Subject: O8W-PM [REDACTED] - Bucks Creek 1101 Phase 1,2&3 - Pre-Engineering Meeting

PM [REDACTED] (Phase 1)

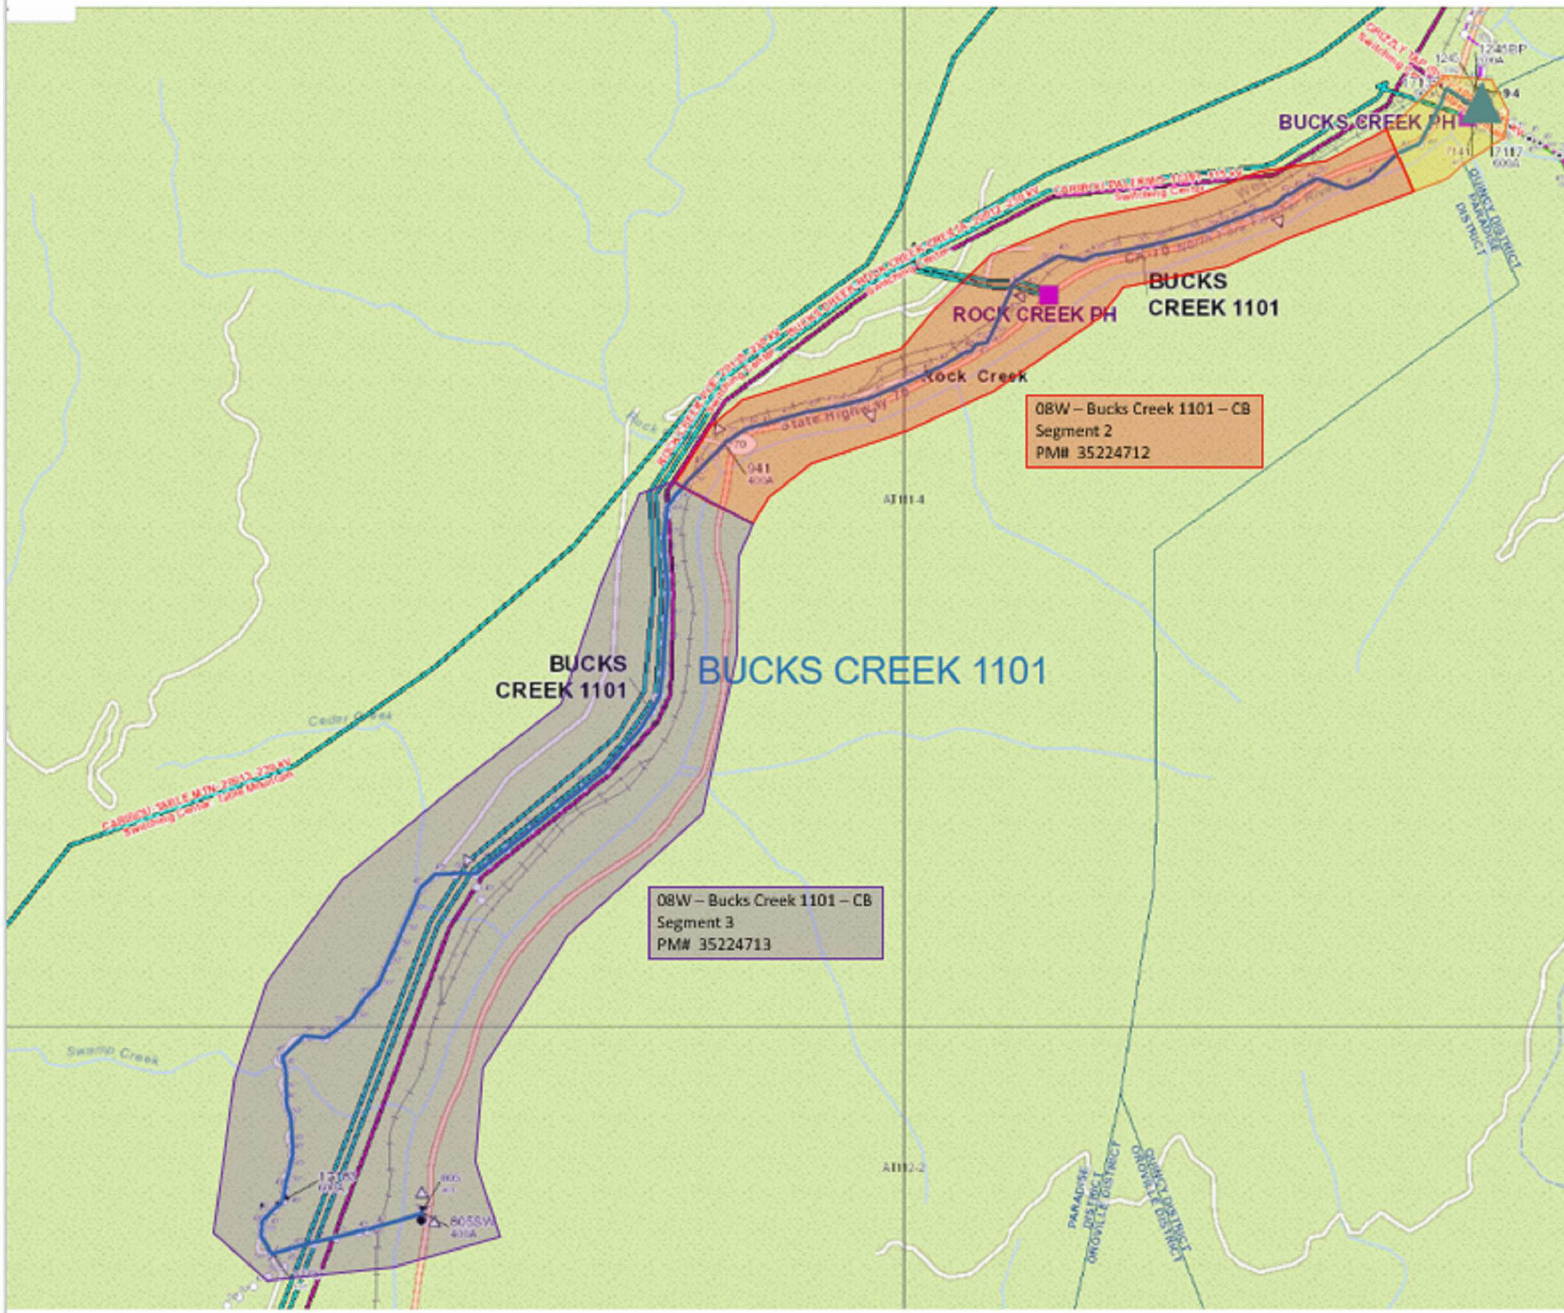
Attached are the 'base-map' limits in a kmz. file. As you will see, we need our base-map to go about ~100' into the tunnel at the south end (see pedestal in picture below....please begin about ~50 beyond this point which is about ~100' beyond the Cresta Dam).

We want to end the base-map at the sign location below which is roughly at MM (Mile Marker) 5.10.
